Access Compliance Report Public Rights-of-Way (Curb Ramps)

Main Street: N/A Cross Street: CERRITOS_AVE Location: NW

ADA ID: RPAT220203145821 Ramp Type: Type 1 - Perpendicular Initial Pass/Fail: Pass Overall Compliance: No Severity Score: 4

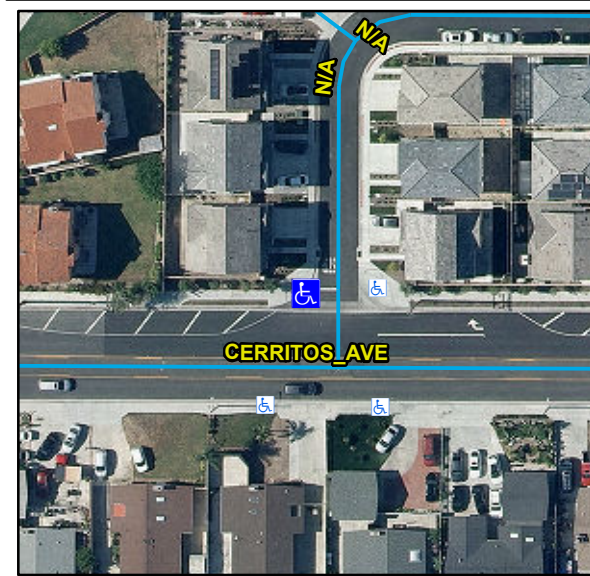
Compliance	Description	Data	Compliance	Description	Data
N/A	Ramp Length (in)	87	N/A	Flare Type LT	
Yes	Ramp Width (in)	48			Sloped
Yes	Ramp Run Slope (%)	7.3	N/A	Flare Slope LT (%)	8.4
Yes	Ramp Cross Slope (%)	0.3	N/A	Flare Traversable LT	No
N/A	Landing Present	Yes	N/A	Flare Type RT	
N/A	Landing Length (in)	37			Sloped
Yes	Landing Width (in)	48	N/A	Flare Slope RT (%)	10.6
Yes	Landing Run Slope (%)	0.3	N/A	Flare Traversable RT	No
Yes	Landing Cross Slope (%)	0	Yes	DWS Provided	Yes
N/A	Landing Movement Obstructed?	No	Yes	DWS Contrast	Yes
	Landing Movement Type	N/A	Yes	DWS Length (in)	36
N/A	Landing Shared	No	Yes	DWS Full Width	Yes
N/A	Clear Space	N/A	Yes	DWS Offset Left (in)	0
N/A	Clear Space To Crosswalk (in)	N/A	Yes	DWS Offset Right (in)	N/A
N/A	Marked Crosswalk 1	No	N/A	Marked Crosswalk 2	N/A
	Crossing 1 Direction	E		Crossing 2 Direction	N/A
	Marked Crosswalk 1 Width (in)	N/A		Marked Crosswalk 2 Width (in)	N/A

Possible Solutions:
Remove & Replace Landing.

OC Std/PROW:
R304.2.1, STD 1115
